Dwelling type:Double Storey
House and Garage

Nature of works: New Build **Stage of inspection:** Frame

Schedule of Defects:

Defects, observations and other related comments from Frame Inspection on.

Figure 3.1.3.2 Site surface drainage

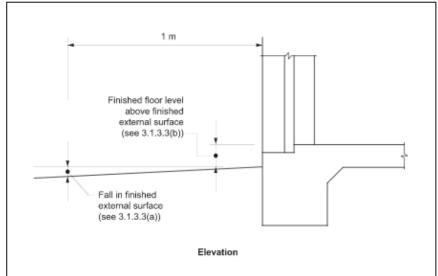
NCC 2019; 3.1.3.3: - The dwellings slab footings have the opportunity to pool with water due to the way the block has been cut and the lack of soil removal.

Water management on site is paramount to ensuring foundations are not damaged. Water, when seeping down beside the slab, between the slab and the dirt softens the dirt. The soils capacity to withstand the downward pressure of the forces of the weight in the slab is greatly reduced.

This dwelling has not met this requirement.

The external finished surface surrounding the slab must be drained to move surface water away from the building and graded to give a slope of not less than a minimum of 50 mm over a distance of 1 m.

We also refer the builder to the soil report and engineering drawings that call for the site drainage to be managed via sloping water away from the slab.

Table 8.18(c) — Structural wall bracing (maximum wall height 2.7 m)

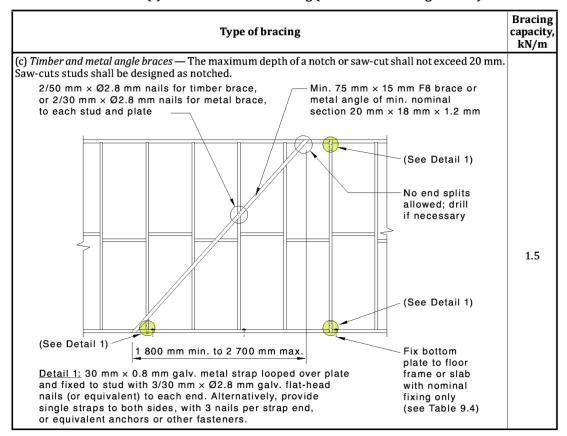
AS 1684.2; Table 8.18 (c): - $2/30 \times 2.8 \text{ mm}$ dia. nails are required at each stud and at top and bottom plates for metal angle braces. Bracing to this dwelling has not met this requirement.

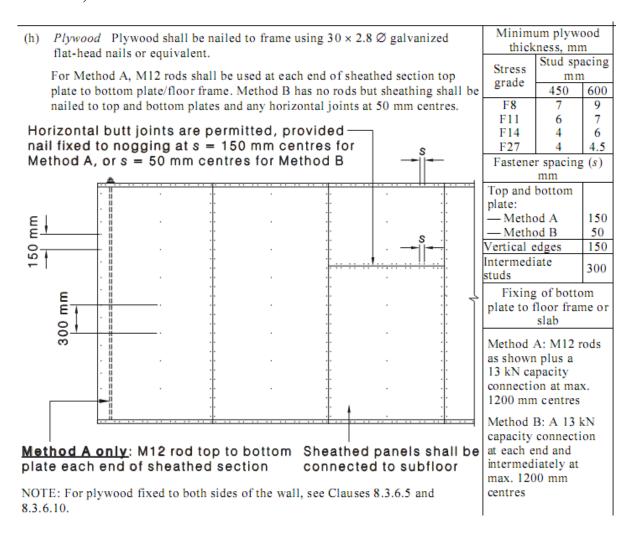
AS 1684.2; 8.3.6: - The timber sheet bracing installation is to resist horizontal racking forces applied to the building.

Areas of the bracing fail to meet these requirements. Details as follows.

- Clouts fastening the sheet bracing have been over punched. Overshot nails compromise the bracing sheet ability to resist racking forces
- The outer sheet edge to be secured at a maximum of 150 centres.

- Intermediate studs to be nailed off at 300 mm centres maximum.
- Complete or part lengths of the sheet to be nailed off.
- A number of the intermediate studs have not been nailed off and as such the nailing is exceeding 600mm spacing.
- Perimeter nailing is within the 10mm minimum distance from the edge of the sheet.

Examples, all areas to comply

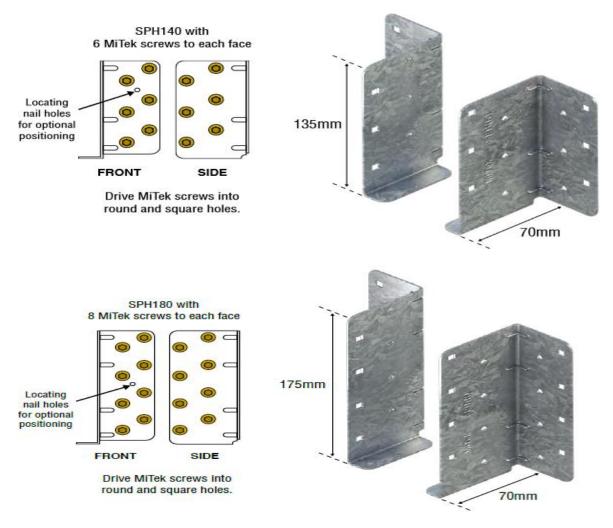
AS 1684.2; Table 9.4: - Lintels shall be nominally fixed to jamb studs with 2/75mm x 3.05 diameter nails at each joint.

This requirement has not been met.

FIGURE 2.3 FIXING OF TRUSSES TO FREESTANDING NON-LOADBEARING WALL THAT IS NOT A BRACING WALL

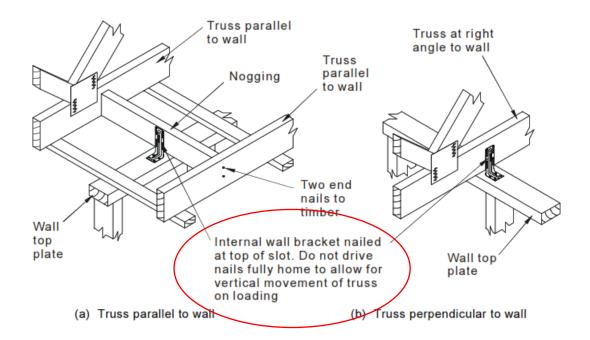
AS 4440; 2.2.3(c): - Internal wall brackets ('L' brackets) shall be installed to non-load bearing walls at 1800 mm maximum spacings.

The 'L' bracket spacing to areas exceeds 1800 mm. As such, this requirement has not been met.

FIGURE 6.3 TYPICAL WALL JUNCTIONS

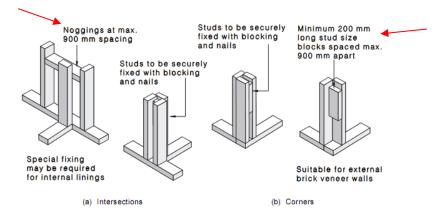
AS 1684.2; 6.2.1.3: - Corner blocks (and nogging, where applicable) to intersecting walls shall be spaced not more than 900mm apart. Corner wall junctions call for a minimum 200 mm long stud sized blocks.

A number of intersecting walls have not met these requirements.

FIGURE 4.2.2(A) ASSESSING FRAMING TOLERANCE

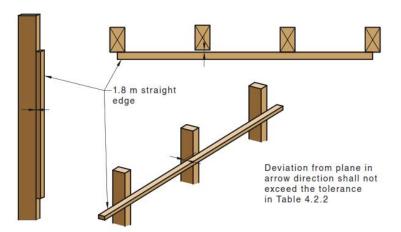
AS 2589, clause 4.2.2 & VBA Standards and Tolerances: - The deviation in the position of the bearing surface of the finished framing immediately prior to installation of lining, shall not exceed the dimensions provided in Table 4.2.2.

Areas in the dwelling exceed this set allowance.

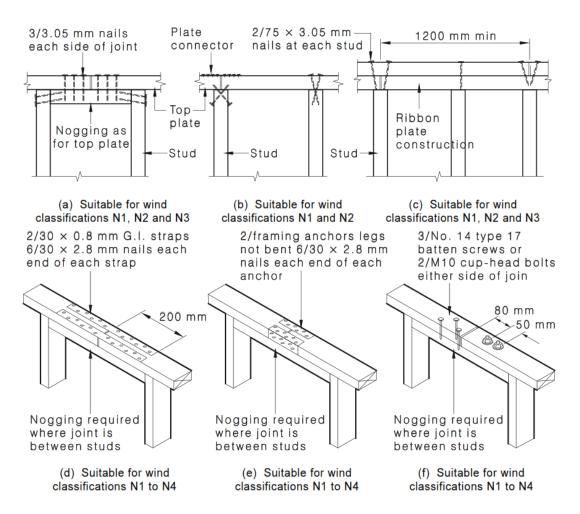
AS 1684.2; 9.2.8: - calls for the installation of a plate connector (gang nail plate or equiv.) at the top of all intersecting walls. Where plates interlock, they are not required.

There are gang nails missing to several of the top plates to the wall's connections. These plates play a vital role in securing one wall to another. It also assists with the racking force resistance on a home.

In areas, top plate connections have not met this requirement.
